**PLANNED UNIT DEVELOPMENT &
SUBDIVISION STAFF REPORT**

Date: September 4, 2003

Accelerated Technology, Inc.

Cottage Hill Executive Park Subdivision,
Resubdivision of Lots 25, 26 and 27, Resubdivision of
Lot 1

SITE PLAN

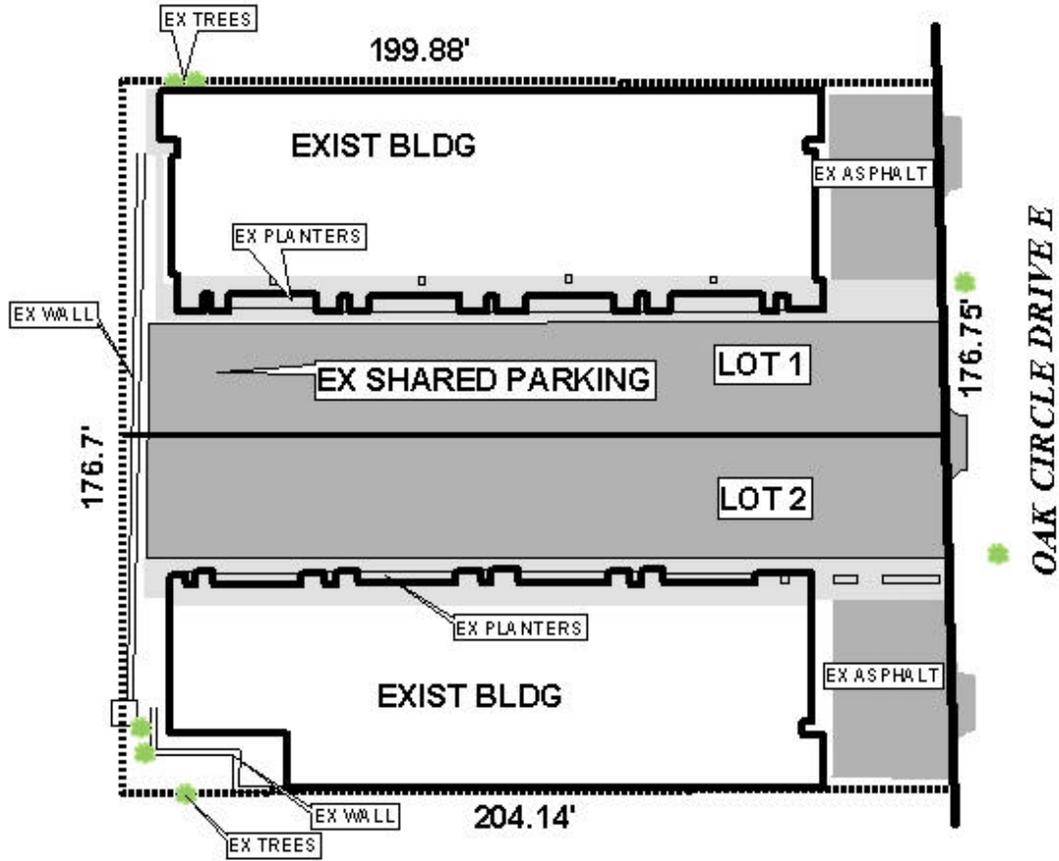
Preservation (removal to be authorized by Mobile
Planning Commission) status be given to the Live Oaks that are on Lot 3 (a 69" Live Oak on
the northwest corner, and an 80" Live Oak on the east side); all work on the above mentioned
trees and all work within the drip line is to be coordinated with Urban Forestry.

Urban Forestry has indicated that there are two significant live oaks on the site and requested that these trees be given preservation status. Preservation status means that the trees are protected in such a manner that they cannot be removed simply through the permitting process, but rather may only be removed under extreme circumstances such as disease or safety and require approval by the Planning Commission. Additionally, all work performed on the tree and under its drip line must be coordinate with Urban Forestry.

RECOMMENDATION **Planned Unit Development:** Based upon the preceding, this application is recommended for approval subject to the following conditions: 1) Preservation (removal to be authorized by Mobile Planning Commission) status be given to the Live Oaks that are on Lot 3 (a 69" Live Oak on the northwest corner, and an 80" Live Oak on the east side); all work on the above mentioned trees and all work within the drip line is to be coordinated with Urban Forestry

SUBDIVISION PLAT

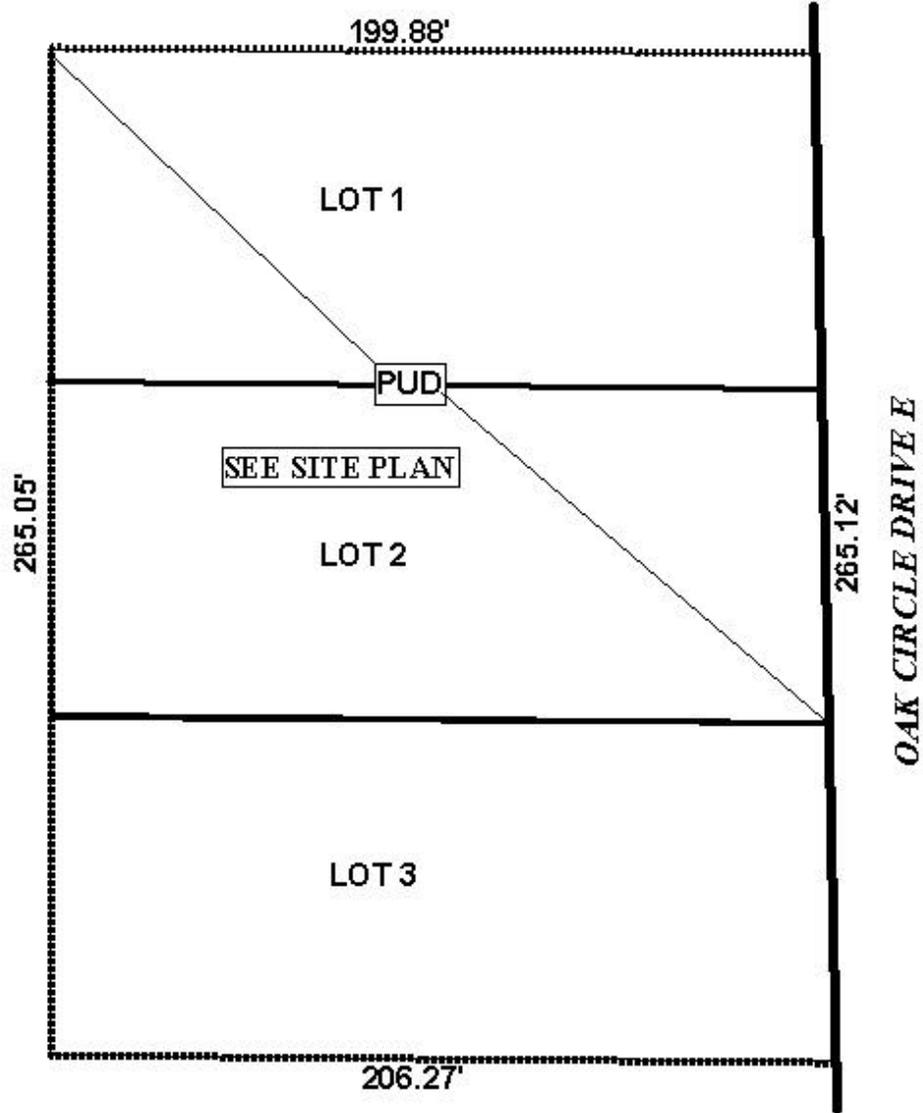
Subdivision: The plat meets the minimum requirements of the Subdivision Regulations and is recommended for Tentative Approval subject to the following conditions: 1) placement of a note on the final plat stating that Preservation (removal to be authorized by Mobile Planning Commission) status be is given to the Live Oaks that are on Lot 3 (a 69" Live Oak on the northwest corner, and an 80" Live Oak on the east side); all work on the above mentioned trees and all work within the drip line is to be coordinated with Urban Forestry.
